## SERVICE CAMPAIGN BULLETIN

CAMPAIGN REF: 039  
TITLE : McLaren 650S US Emissions Label Correction  
DOCUMENT # : 11 P 003  
AFFECTED VEHICLES : McLaren 650S Coupe and Spider

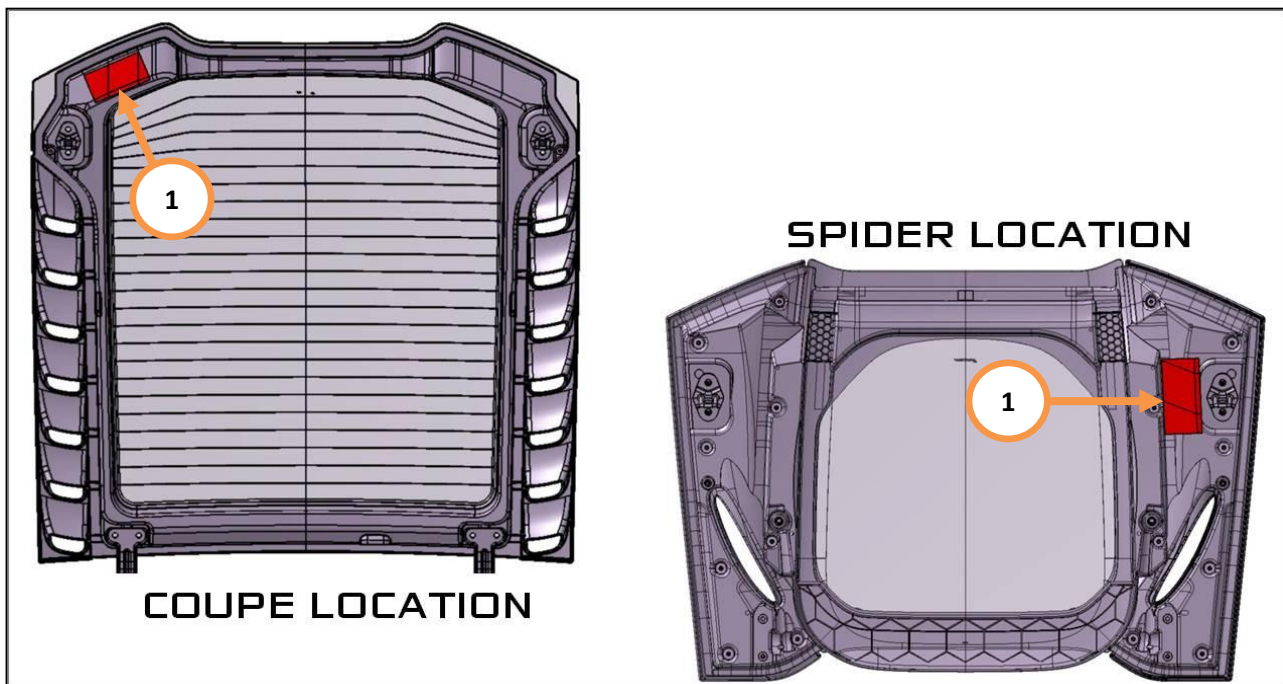
**SITUATION :** Quality Engineering at McLaren Automotive have identified that a number of vehicles have been fitted with VECI (US Emission) label which has a typing error on them.

**PROCEDURE :** It is necessary to replace the current VECI label with the new label with the correct reference on. Please follow the instructions outlined in this document.

1. Open the engine cover.
2. Remove the existing VECI (US Emission) label (1).
3. Clean the surface with an alcohol cleaning solution or similar product to remove any dirt.
4. Install the new label 11P0443CP where the old label was installed.
